# Panel Submission – Part B

## Planning Scheme Amendment C131latr Flood Overlays Update

Latrobe City Council and West Gippsland Catchment  
Management Authority

Circulated 8 July 2024

*Figure 3: Draft extent of LSIO and FO from Traralgon Flood Study 2016*

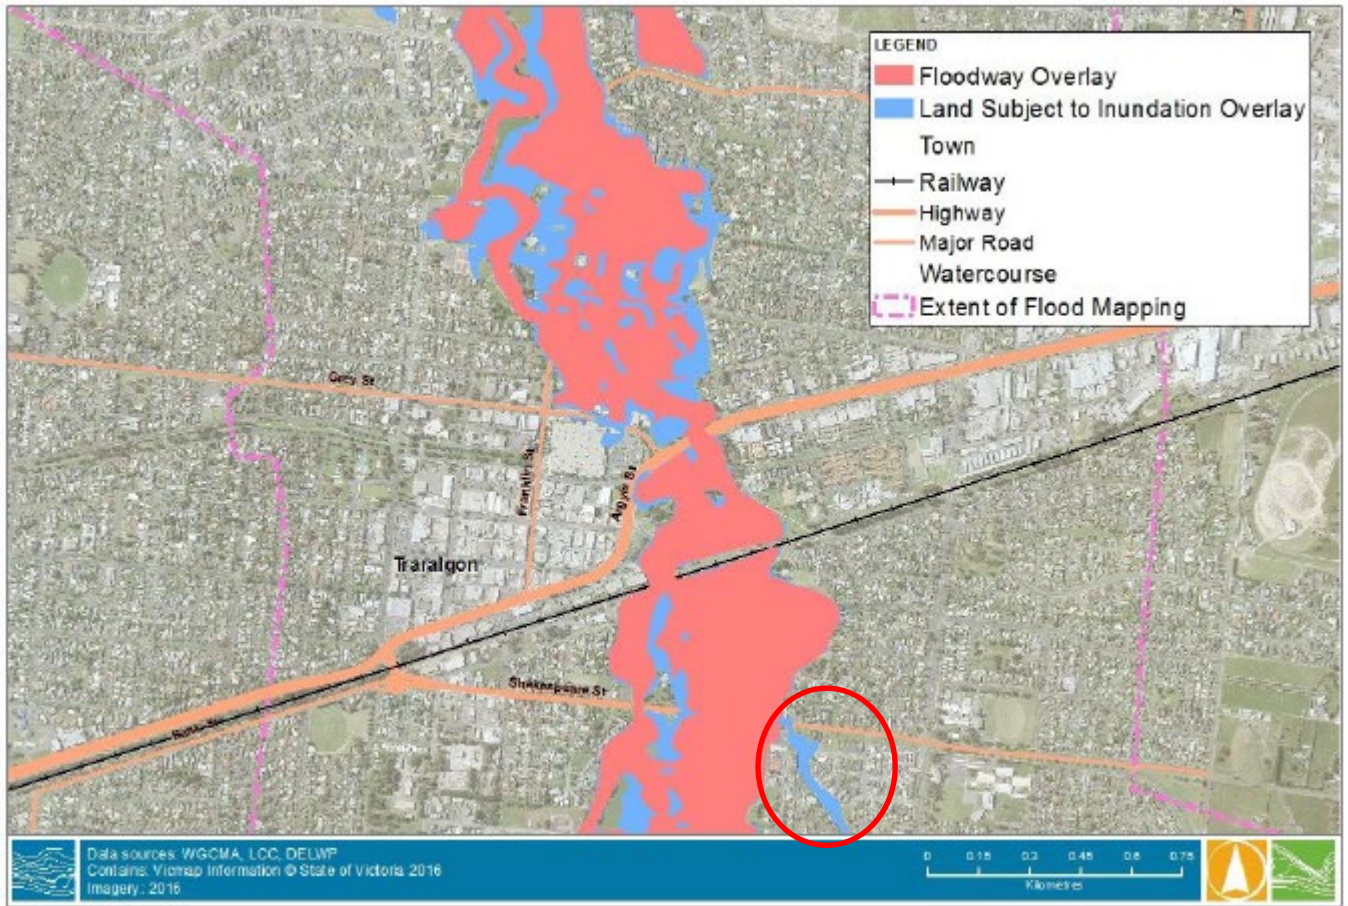
36. The mapping that was re-exhibited between 29 February 2024 and 5 April 2024 was consistent with the recommendations of the *Traralgon Flood Study 2016* as shown in Figure 3 except for the overland flow path starting from Shakespeare Street.

37. The overland flow path was removed as it was determined to be from stormwater flooding based on WGCMA’s criteria identified earlier (point 33).

39. As the Amendment was re-exhibited without the pockets of stormwater, this issue is considered resolved.
40. Council has proposed no further changes in response to the submissions received based on this theme.

Figure 4: First Exhibition of Proposed LSIO with Aerial dated 13 March 2014.

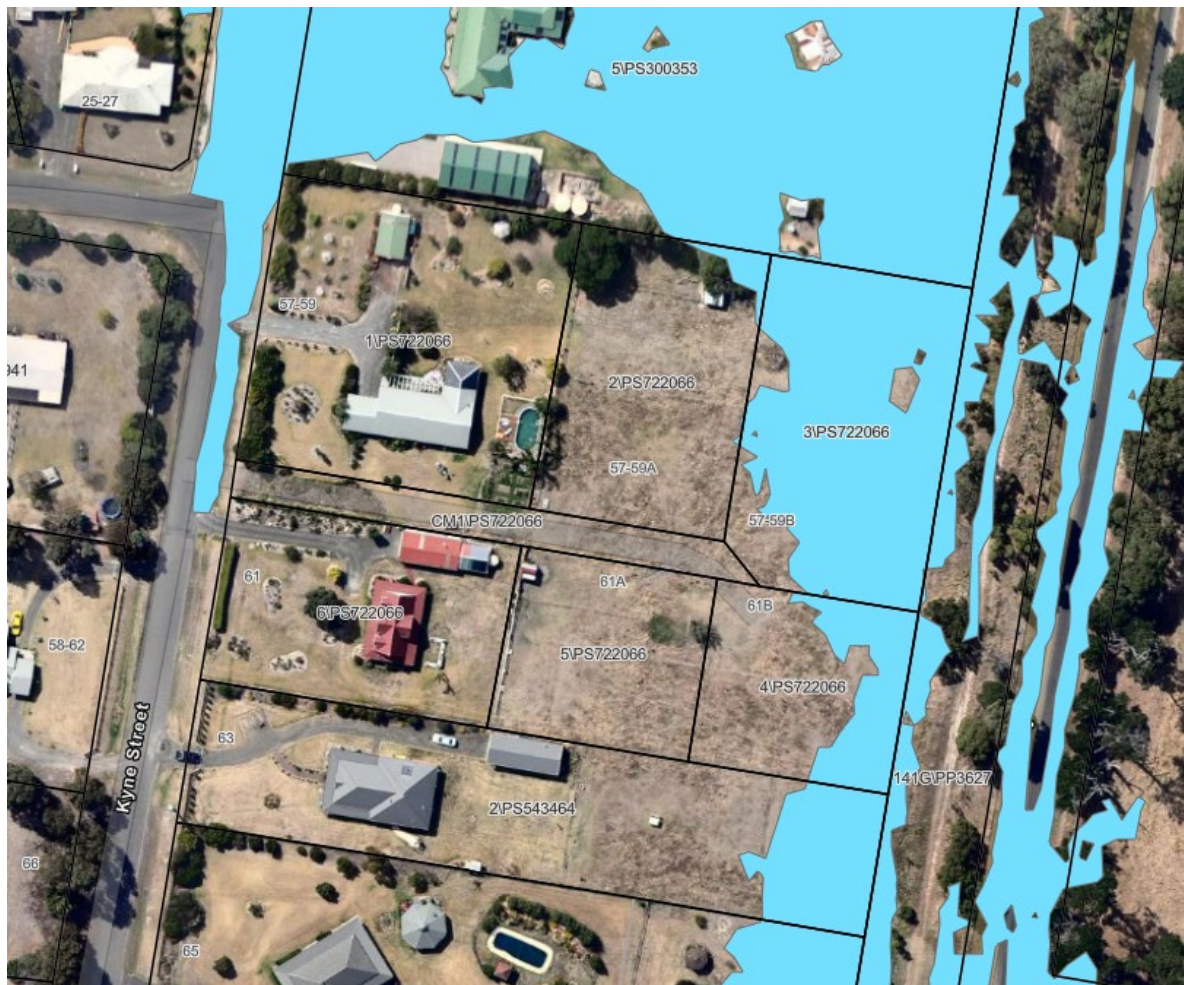
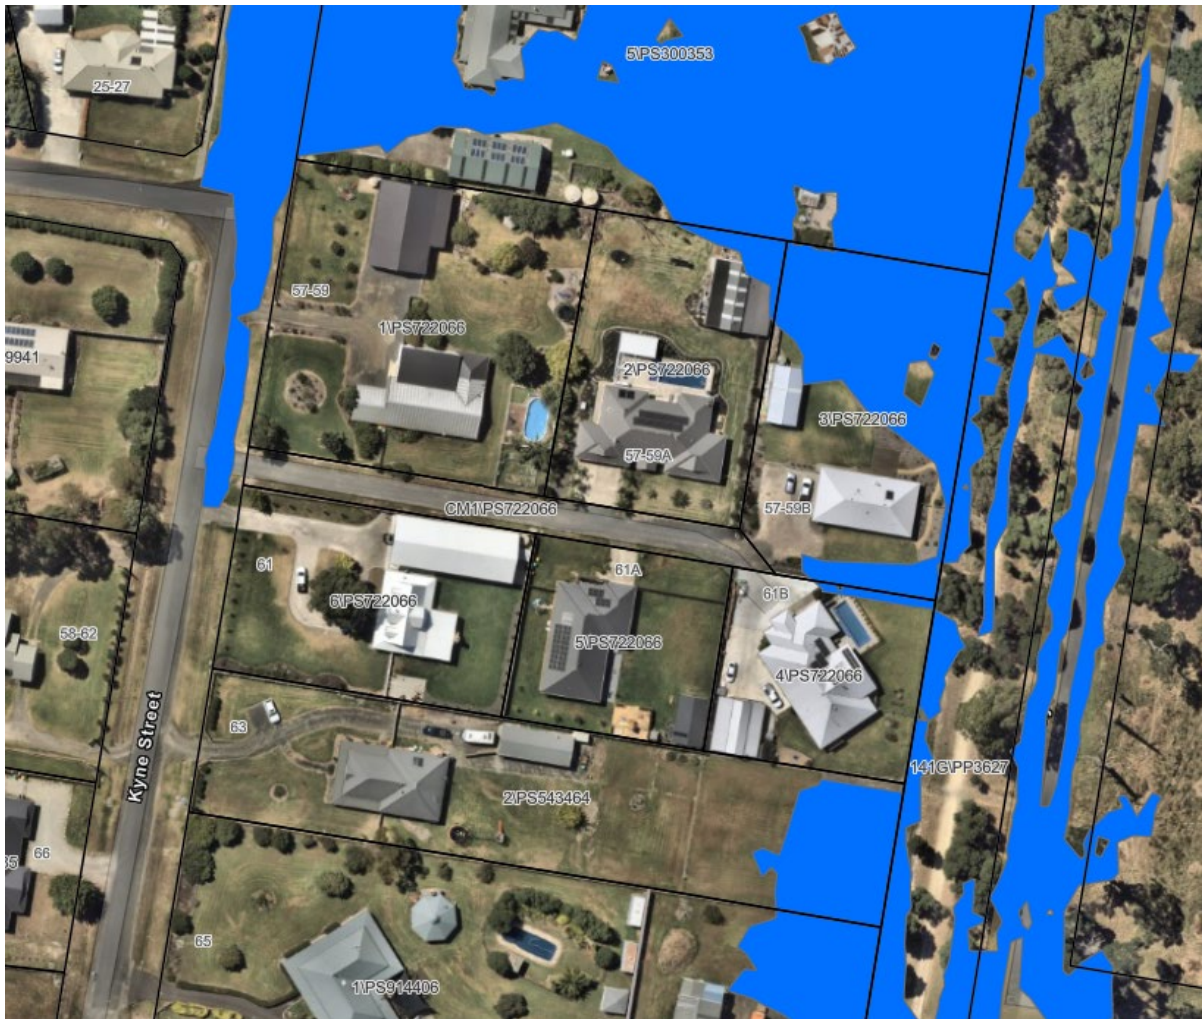
72. **57-59B & 61B Kyne Street, Glengarry**
73. Submitters objected on the basis that their properties had been developed after the flood study was undertaken.
74. The *Floodplain Mapping at Glengarry/Eaglehawk Creek* uses aerial photography from 2014 and the elevation data across the three datasets ranges from 2006 to 2011.
75. In response to submission, it was found that development had occurred after the initial flood modelling was undertaken and the development had raised areas of the two properties, as such, the proposed overlays were readjusted. This adjustment occurred prior to the Re-Exhibition of the Amendment. The submissions relating to these properties were subsequently withdrawn. The difference between the first exhibition and the Day 1 version is shown in Figure 4 and Figure 5.

77. The flood overlays are proposed to be amended as per the Day 1 version of Maps 15LSIO-FO, 16LSIO-FO, 17LSIO-FO, 18LSIO-FO, and 19LSIO-FO.
78. This has resulted in a large number of properties down Carey Drive, Moorhouse Close, King Road, and Hambrook Lane having the overlay removed. Only minor changes occurred on the western side of Glengarry. As such, no changes are proposed on submitter 3, 6, 21, 22, 41 and 62's properties. Overlays are proposed to be partially removed from submitter 11 and 21's properties.

Figure 6: Proposed overlays with 2023 and 2024 Property Cadastre

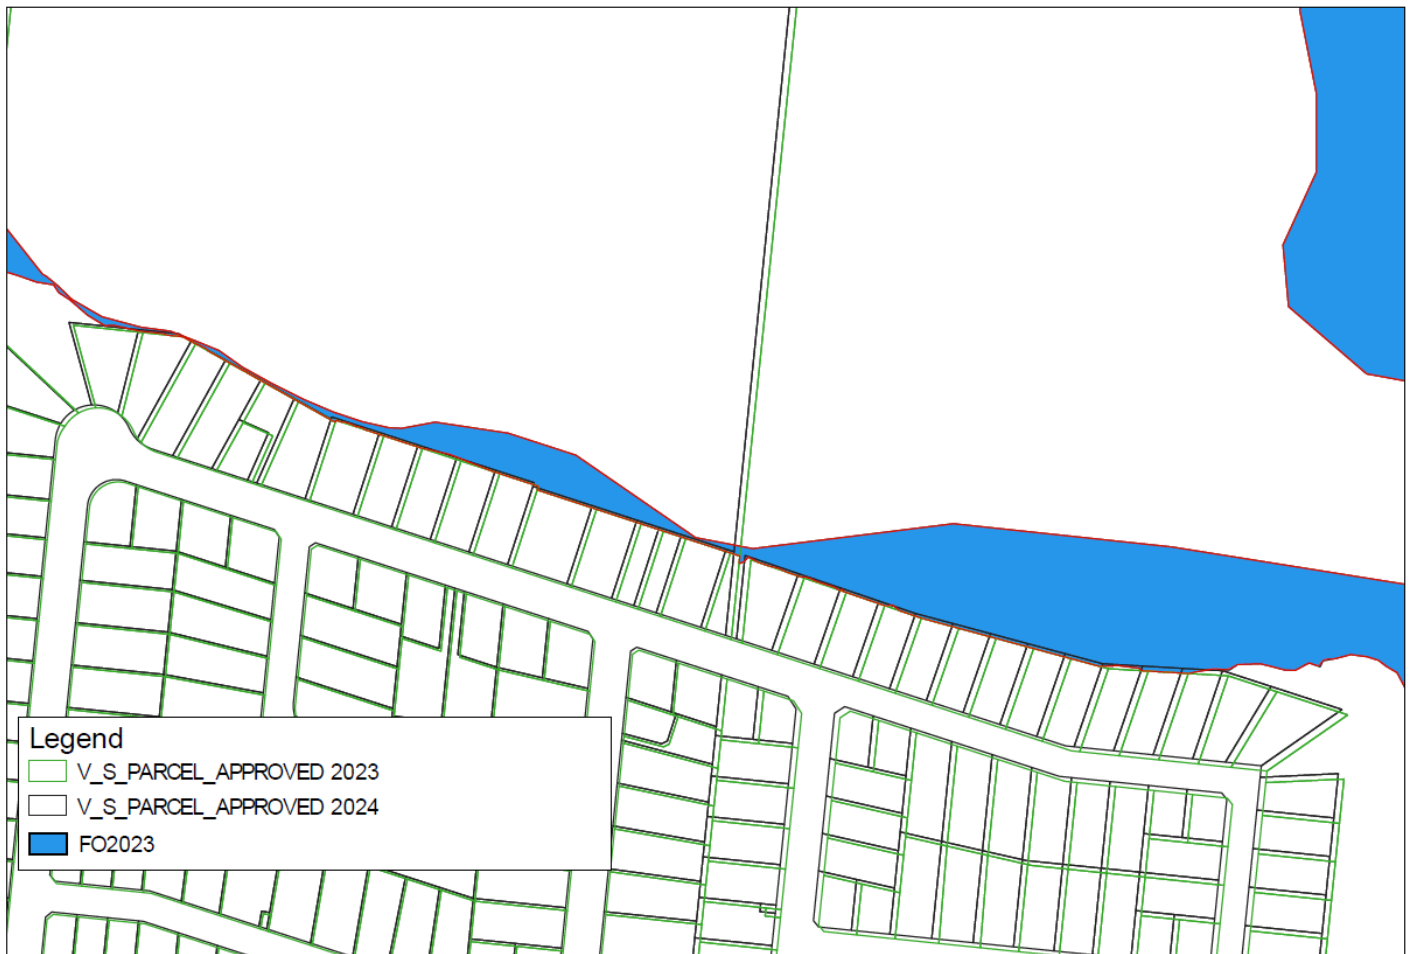
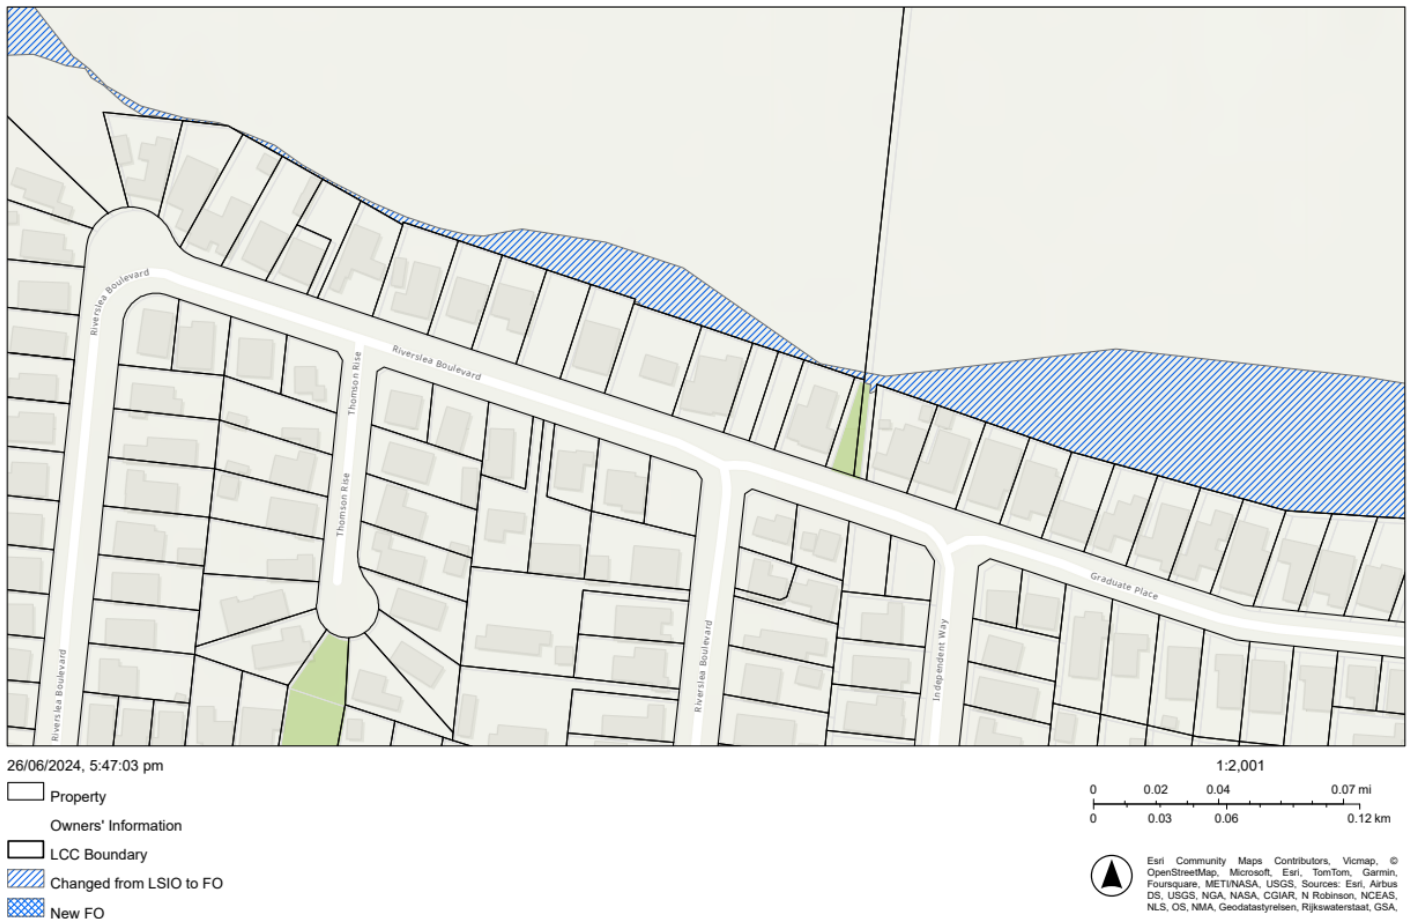
- 122. Several submitters (38, 47 and 64) did not want the proposed flood overlays on their properties as the northern portion of the land was filled to ensure it was above the 1%AEP flood level and a 400mm high retaining wall was constructed along the northern boundaries of the properties along Riverslea Boulevard, Independent Way, Graduate Place and Earl Court.

123. This change also relates to submitter 12, 48 and 59’s properties but they did not raise it as a reason why the proposed flood overlays were inappropriate.
124. WGCMA undertook a site inspection and a desktop review of the mapping in this area. It was found that the mapping was based on outdated lidar/land level information. The mapping was adjusted to reflect new lidar/land level information
125. **Planning Comment**
126. In response to submissions, the overlay was proposed to be clipped to the rear property boundary prior to Re-Exhibition.
127. However, in late 2023 a four-year program to accurately display Victorian property boundaries in a digital format was completed. This shifted the property boundaries but not the geo-referenced coordinates of the overlays, which resulted in a thin strip of FO being re-exhibited on the properties as seen in Figure 6.

128. WGCMA and Latrobe City Council were made aware of this mapping error during the Re-Exhibition of the Amendment and as such the proposed change in response to submissions is to clip the proposed overlays to the rear boundary as shown in Figure 7.

137. Council proposes to amend maps 48LSIO-FO, 49LSIO-FO, and 50LSIO-FO in response to submissions and the subsequent reviews that were undertaken by WGCMA.

Figure 8: Re-Exhibition Version of Proposed Overlays on Oxford Place and Waterford Court

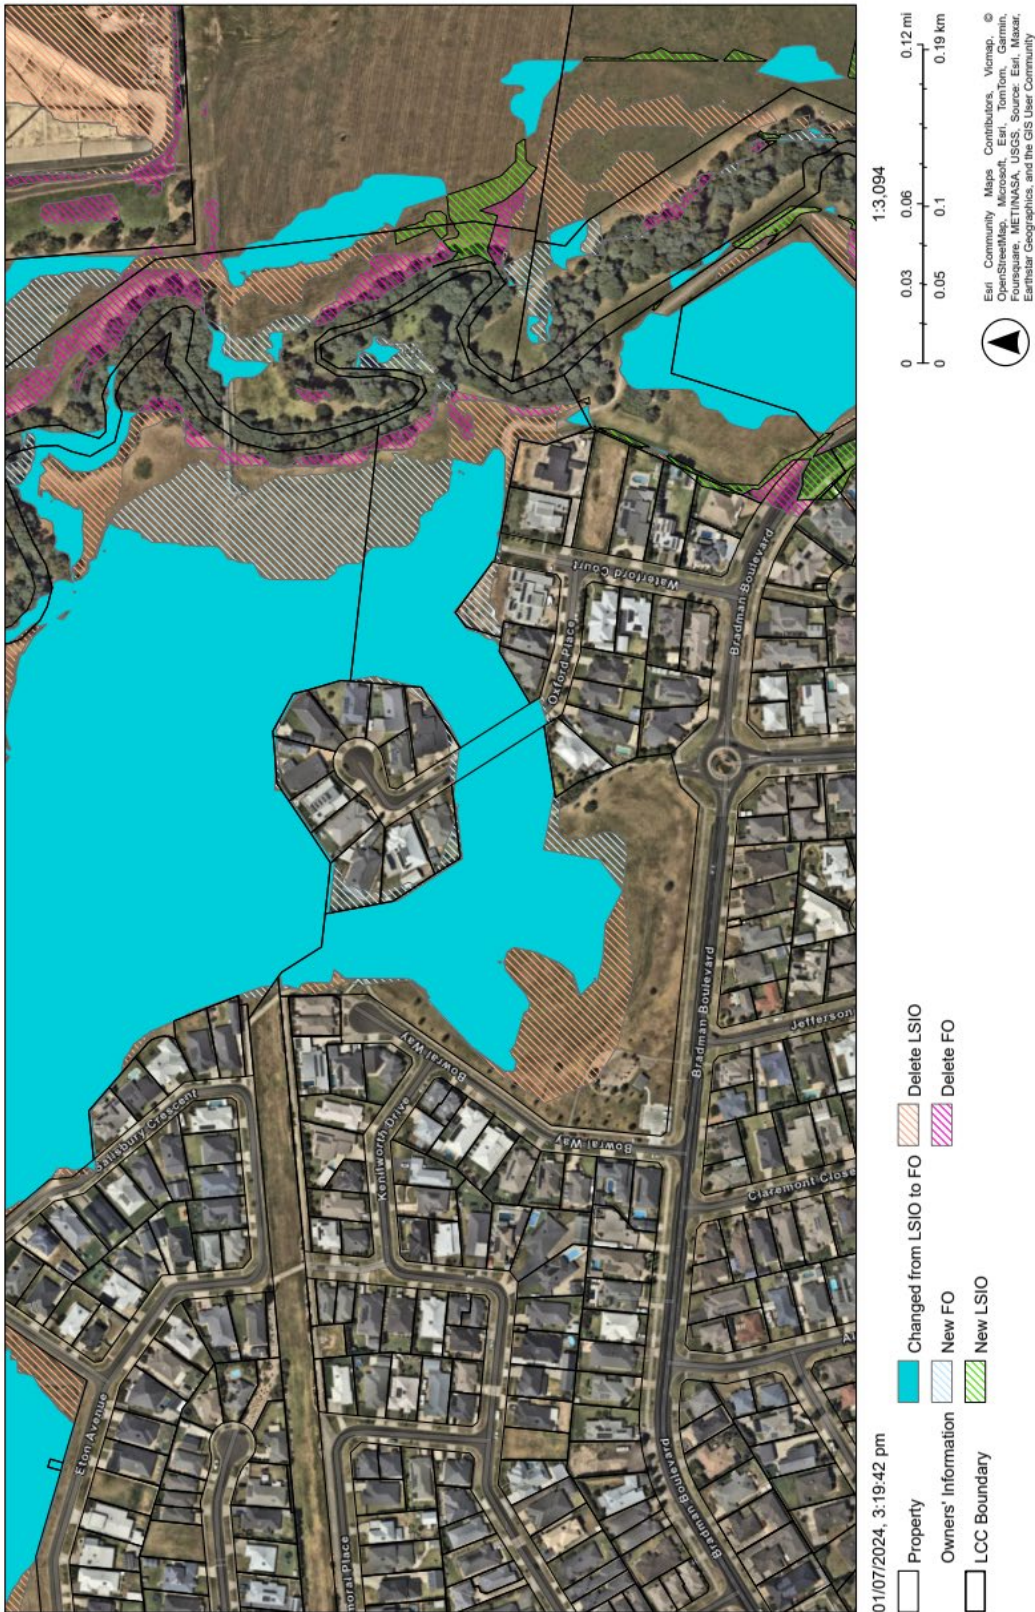
130. The properties in Oxford Place were subdivided in 2013 and development has occurred between 2015 and 2020 with the last house currently under construction.

131. In response to the submissions, WGCMA undertook a desktop review of new lidar/land level information for this area. An inspection of the area was also undertaken. This review and the visual inspection confirmed that land levels in this area had been raised as part of the development. The overlay extents were subsequently revised based on new lidar (2019) information.
132. The proposed changes in the Day 1 version compared to the Re-Exhibition version are shown in Figure 8 and Figure 9.
